Joint Inspection Report
(22.12.2020)
of
M/s Rudra-bilas Kisan Sahkari Chini Mills, Ltd. Bilaspur, Distt.
Rampur (U.P.)

In the Matter Of
M/s Kisan Sahkari Chini Mills Ltd. Vs Member Secretary,
UPPCB and Ors.

Appeal No. 23/2020, 24/2020 & 25/2020

-Prepared by-
The Joint Committee of CPCB & UPPCB

15. Open dumping and mismanagement of bagasse storage

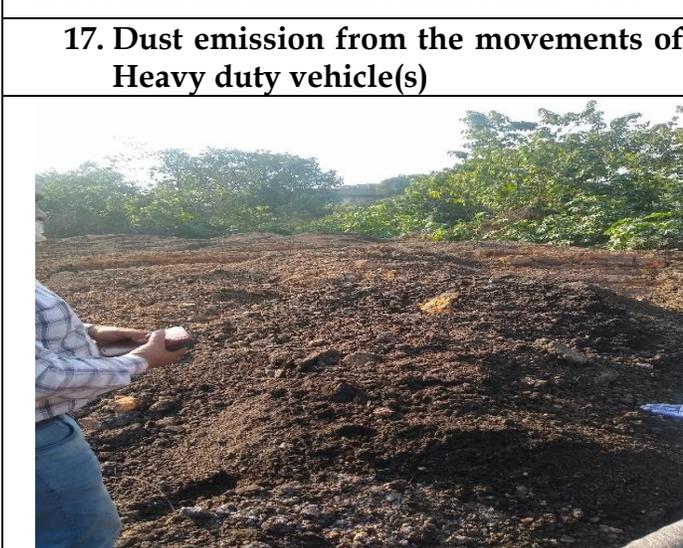
13. The unit shall improve its overall housekeeping.
14. The unit needs to make a proper management of bagasse and arrangements shall be made to feed the bagasse via closed chute into boiler.

20. Dry and Empty Lagoon-No treated water for irrigation

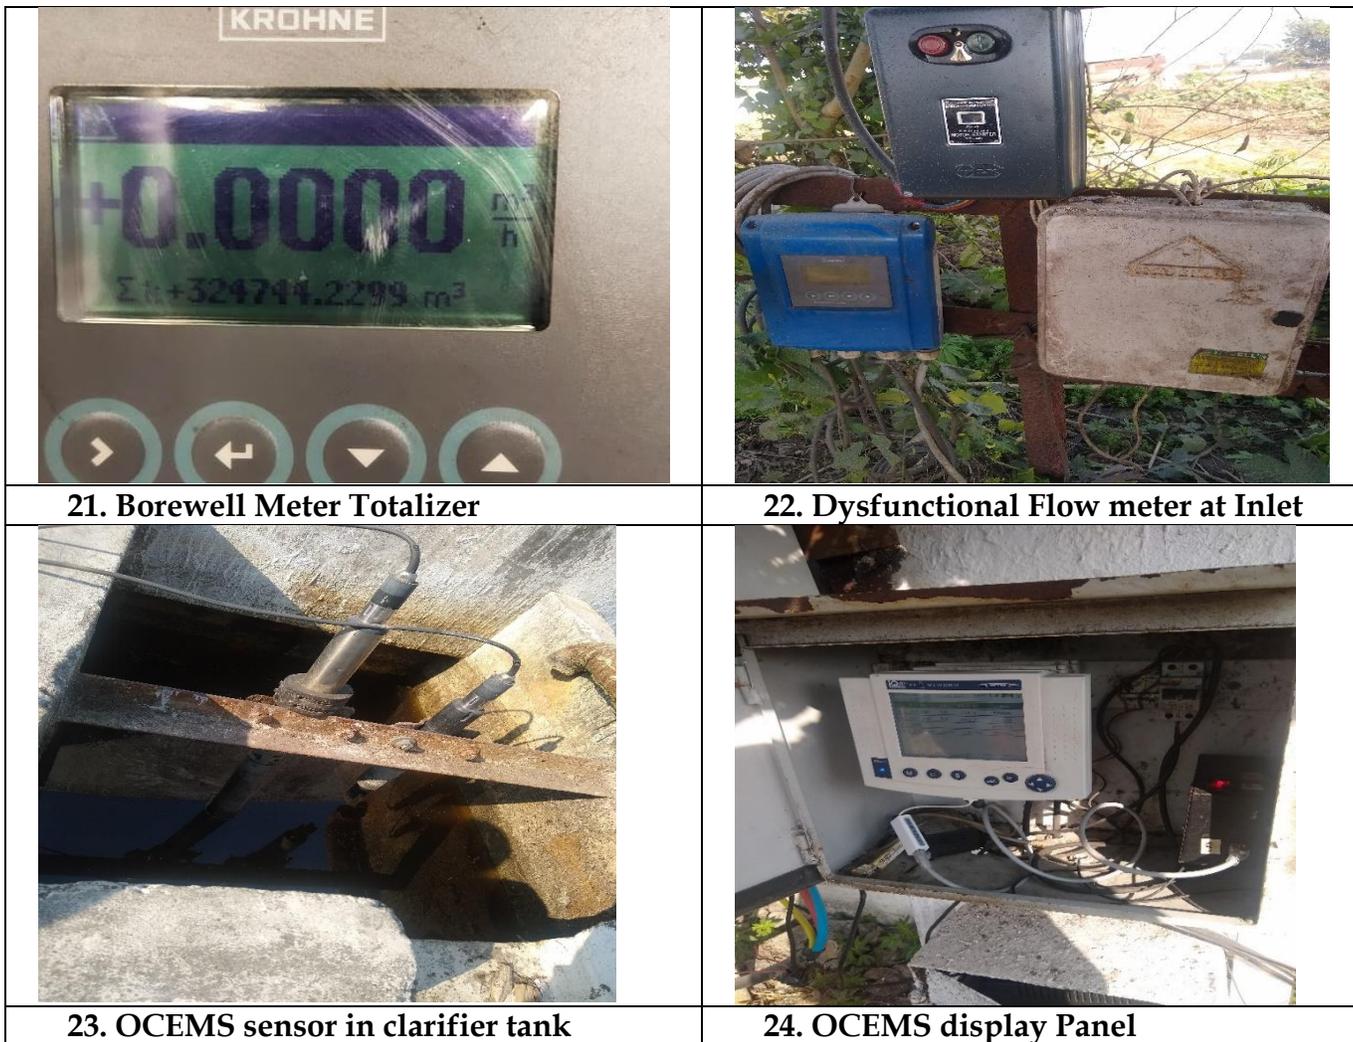
18. At the time of inspection, the lagoon having capacity 6000 m³ for storage of treated effluent was found completely empty and dry. Thus, it can be deduced that the Unit is not operating the ETP properly and bypassing the untreated effluent instead of holding treated water for the irrigation purpose as per the conditions of consent.
